STAFF REPORT
COMMUNITY DEVELOPMENT DEPARTMENT

HEARING DATE: 11/16/2021, 1/4/2022, & 7/19/2022
 TO: Mayor & City Council
 FROM: Joe Dodson, Associate Planner
 208-884-5533
 SUBJECT: H-2021-0046
 Centerville Subdivision
 LOCATION: The site is located at 4111 E. Amity Road (including the outparcel to the south) and 5200 S. Hillsdale Avenue, at the southeast corner of S. Hillsdale and E. Amity, in the NW ¼ of the NE ¼ of Section 33, Township 3N., Range 1E.

D. Landscape Plans (date: ~~6/07/2021~~ 10/15/2021)

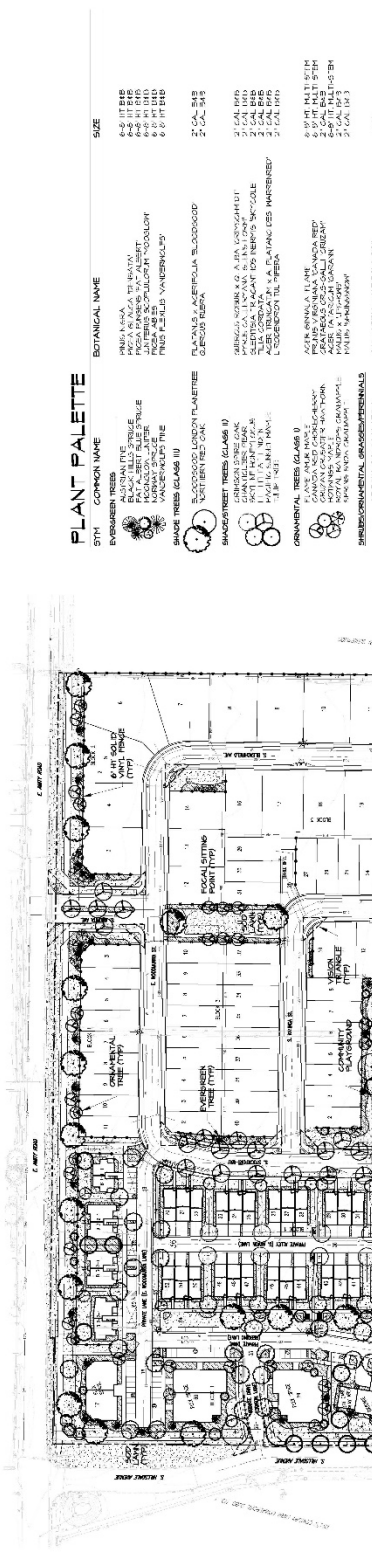
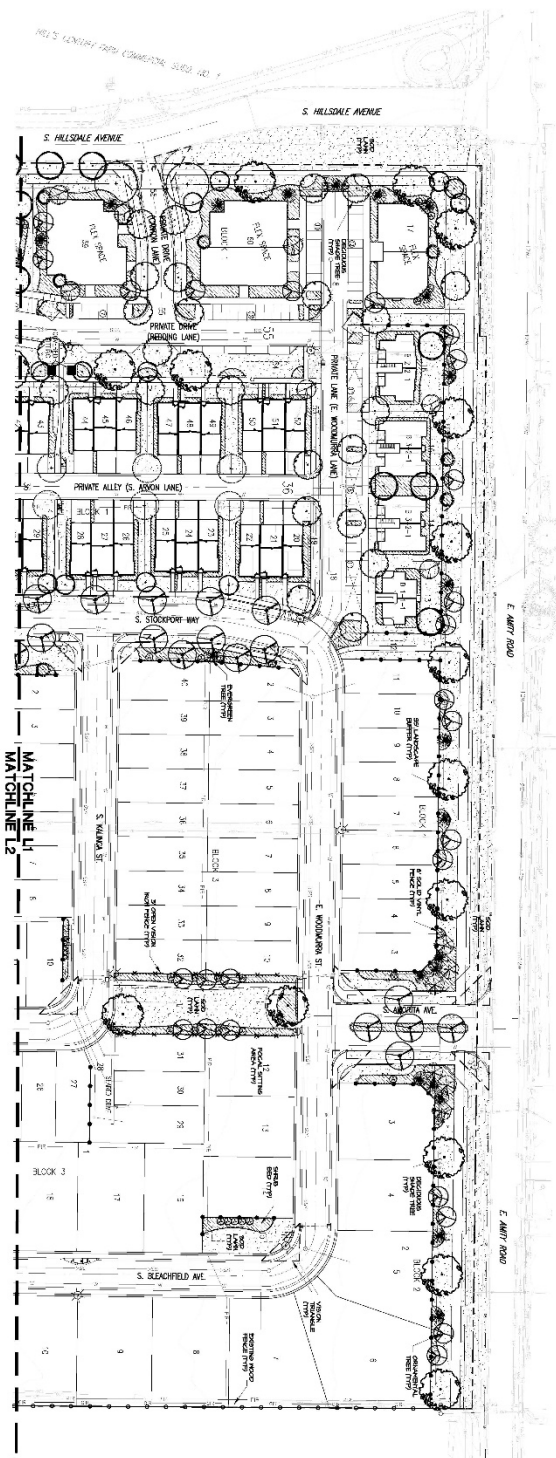
Landscaping is required along all pathways (including micro-pathways) in accord with the standards listed in *UDC 11-3B-12C*. The total lineal feet of *all* pathways with the required and proposed number of trees are not included in the Landscape Calculations table on the submitted landscape plans. This should be corrected prior to Final Plat submittal. However, the correct number of trees appear to be shown on the submitted plans. *The Applicant has proposed a micro-path in the southeast corner of the site to connect two blocks and the correct number of trees is shown on the landscape plans but there are no trees shown adjacent to the pathway to offer any shade. The pathway segment is slight over 100' which requires only one tree adjacent so the Applicant should move one tree from a portion of this common lot and place it next to the pathway to comply with UDC 11-3B-12C.*

4. The landscape plan included in Section VII.D, dated ~~June 7, 2021~~ October 15, 2021, is approved as submitted. ~~shall be revised as follows at least ten (10) days prior to the City Council hearing:~~

- a. ~~Revise the landscape plans to match the revised preliminary plat;~~
 - b. ~~Per UDC 11-3B-12C, place at least one tree along the micro path located on Lot 30, Block 5, as labeled on the revised preliminary plat.~~
